## PROPOSED SITE DEVELOPMENT PLAN

Project: New Mexican Restaurant  
At: 327 Wyoming Boulevard NE  
Albuquerque, New Mexico 87123

ENGINEER CERTIFICATION FOR (K19-D122)

GRADING & DRAINAGE PLAN

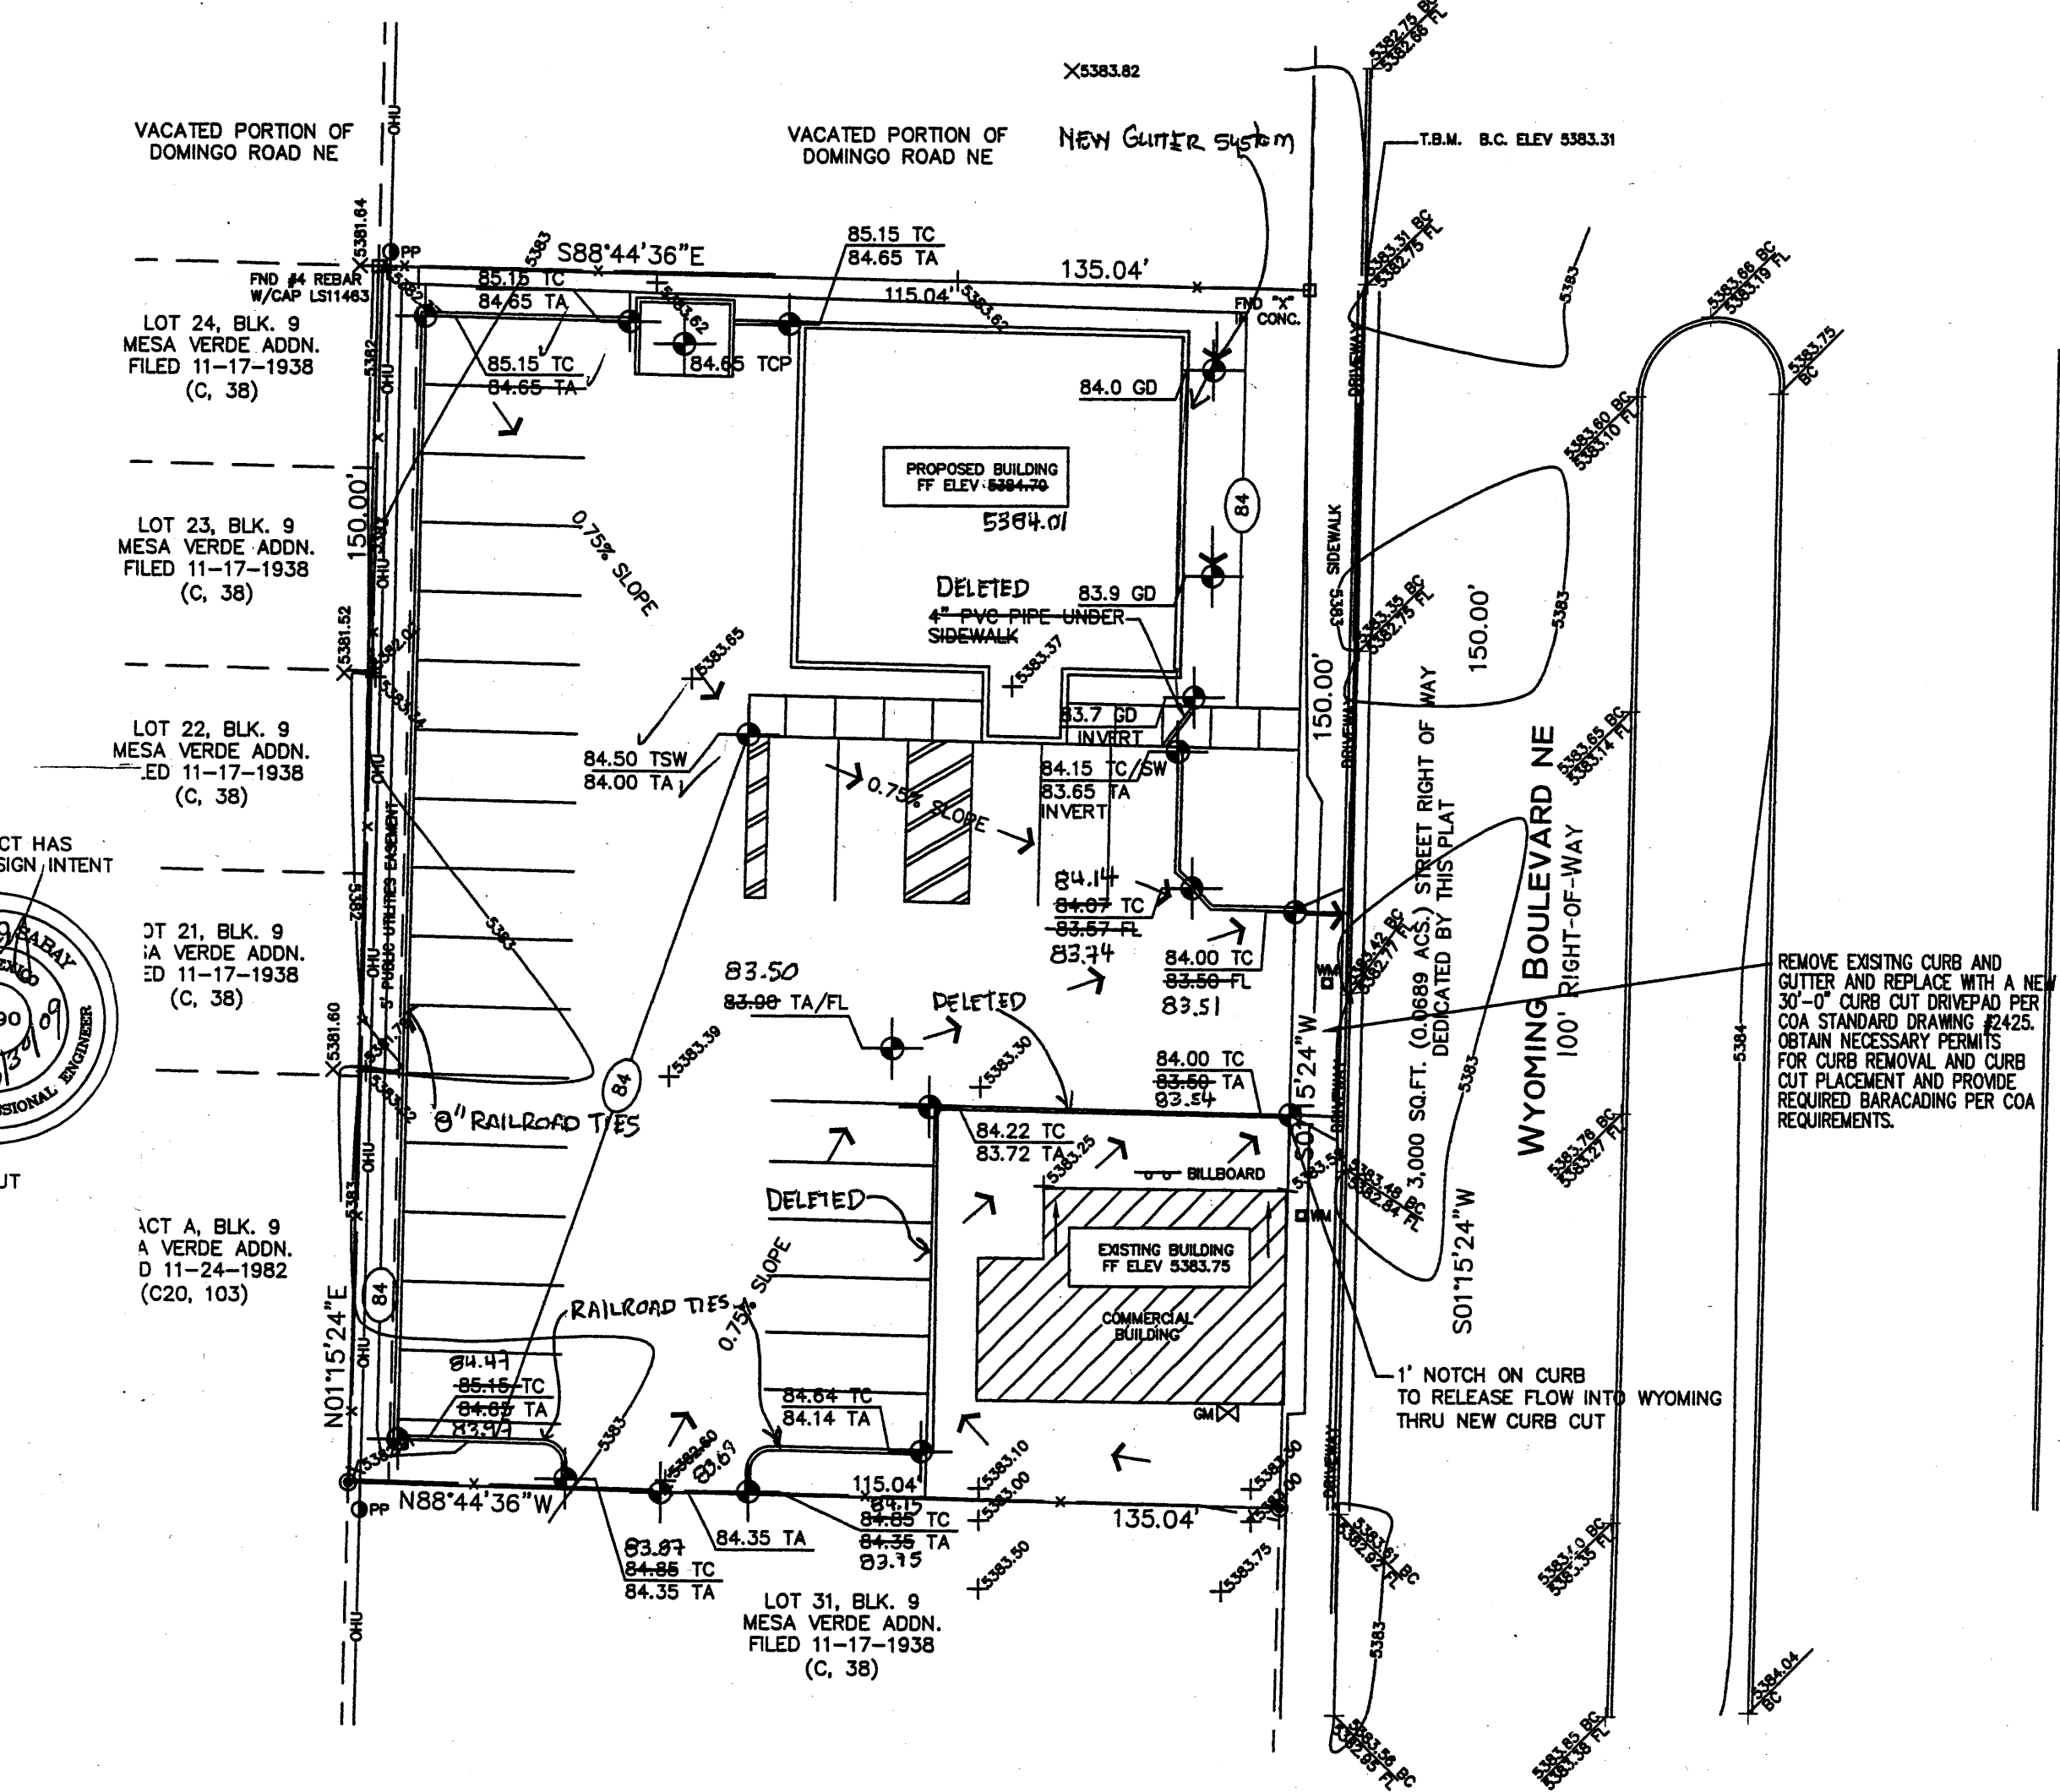
I, EFRACIO SEBAY, NMPE # 6790, OF THE FIRM B.J.M. CONSULTING, HEREBY CERTIFY THAT THE PROJECT HAS BEEN GRADED AND WILL DRAIN IN SUBSTANTIAL COMPLIANCE WITH AND IN ACCORDANCE WITH THE DESIGN INTENT OF THE APPROVED PLAN DATED 04/29/2008. THE RECORD INFORMATION EDITED ONTO THE ORIGINAL DESIGN DOCUMENT HAS BEEN OBTAINED BY ME OR UNDER MY DIRECT SUPERVISION AND IS TRUE AND CORRECT TO THE BEST OF MY KNOWLEDGE AND BELIEF. THIS CERTIFICATION IS SUBMITTED IN SUPPORT OF A REQUEST FOR RELEASE OF A CERTIFICATE OF OCCUPANCY. THE FOLLOWING ITEMS HAVE BEEN DELETED OR CHANGED:

- CONCRETE HEADER CURBS HAVE BEEN CHANGED TO 8" RAILROAD TIES AS SHOWN ON PLAN DRAWING FOR CERTIFICATION.
- CONCRETE CURB AROUND EXISTING BUILDING WAS OMITTED AND ASPHALT PLACED AND SLOPED AWAY FROM THE BUILDING AS SHOWN ON PLAN DRAWING.
- PROPOSED 4" PVC PIPE HAS BEEN DELETED.
- GUTTER SYSTEM ON THE EAST SIDE OF BUILDING HAS BEEN TRANSITIONED SO THAT A DOWNSPOUT IS NOW LOCATED ON THE SOUTHEAST CORNER OF THE NEW BUILDING TO KEEP RUN-OFF AWAY FROM THE PUBLIC SIDEWALK ON WYOMING BLVD.
